Access Compliance Report

Public Rights-of-Way

Intersection ID: N/A	Main Street: 3RD_ST	Cross Street: CHARLOTTETOWNE_AV	Location: SW
ADA ID: 2645B0FB2883	Ramp Type: Perp	Initial Pass/Fail: Fail	Overall Compliance: No
Codes/Mitigation Info/Possible Solution		Field Measurements/Component Compliance	
Severity Score: 46.25

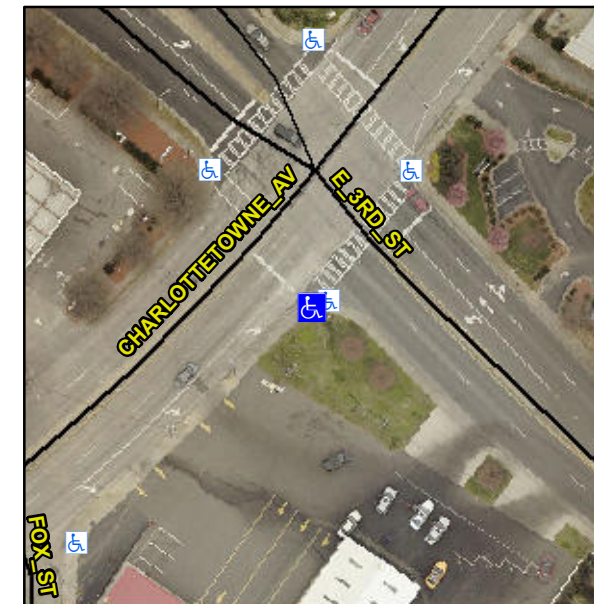
R304.5.1, R304.2.2, R304.5.3

Compliance	Description	Data	Compliance	Description	Data
N/A	Ramp Length (in)	60.5	No	Ramp Slope (%)	14.4
No	Ramp Width (in)	42.0	No	Ramp XSlope (%)	5.4
N/A	Flare Type LT	N/A	N/A	Flare Type RT	N/A
N/A	Flare Slope LT (%)	N/A	N/A	Flare Slope RT (%)	N/A
N/A	Flare Traversable LT?	N/A	N/A	Flare Traversable RT?	N/A
N/A	Landing Length (in)	N/A	N/A	DWS Provided?	N/A
N/A	Landing Width (in)	N/A	N/A	DWS Contrast?	N/A
N/A	Landing Slope (%)	N/A	N/A	DWS Length (in)	N/A
N/A	Landing X Slope (%)	N/A	N/A	DWS Full Width?	N/A
N/A	Landing Curb? (Y/N)	N/A	N/A	DWS Offset (in)	N/A
N/A	Shared Landing?	N/A			
N/A	Gutter Ponding?	N/A	N/A	Gutter Slope (%)	N/A
N/A	Gutter Lip Ht (in)	N/A	N/A	Gutter X Slope (%)	N/A
N/A	Painted X Walk1?	No	N/A	Painted X Walk2?	N/A
	X Walk 1 Direction	To NW		X Walk 2 Direction	N/A
N/A	X Walk 1 Width (in)	N/A	N/A	X Walk 2 Width (in)	N/A
	X Walk 1 Slope (%)	2.2		X Walk 2 Slope (%)	N/A
	X Walk 1 X Slope (%)	2.2		X Walk 2 X Slope (%)	N/A

Remove & Replace Entire Ramp.
